2024-25 Design, Build, Fly Q&A #4

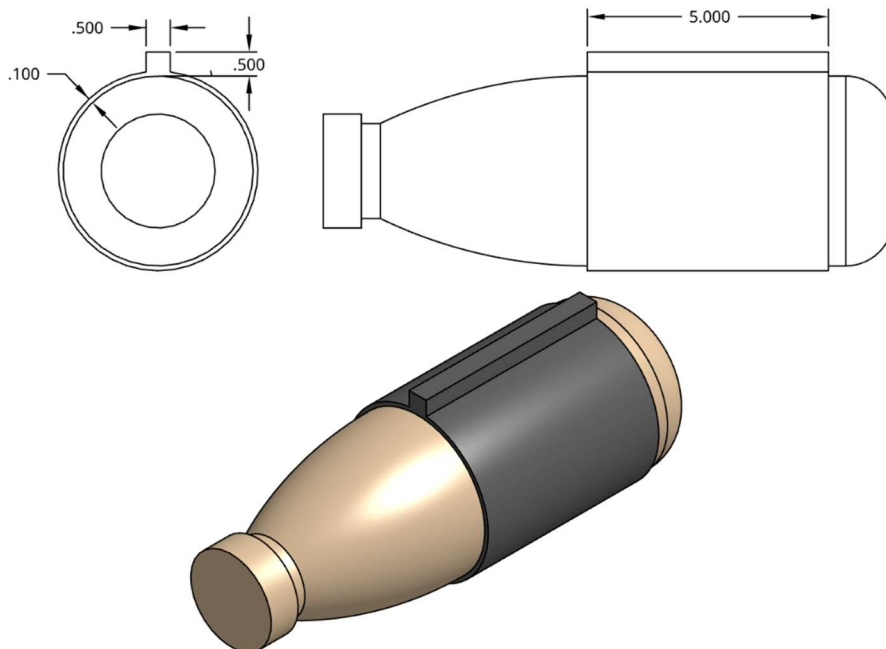
1. Can a commercially available LiPo split-pack be used for a single propulsion system?

Answer: Yes, assuming that the configuration can be confirmed in Tech Inspection that it is connected to a single propulsion system.

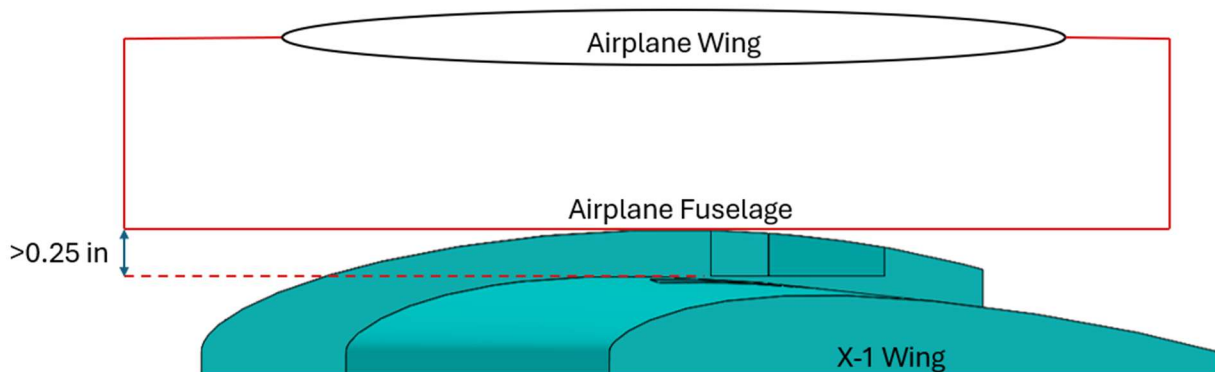
22. If clamps are implemented with the bottle adapter, would they contribute towards the total fuel tank weight?

If a team chooses to implement an adapter, it will be part of the total weight of the fuel tank?

Does the adapter that can be permanently attached to the bottles count towards the mass of the bottles in M2? Or will they have to be removable to be weighed?

Answer: Yes, the adapter and clamps will be part of the total fuel tank weight.
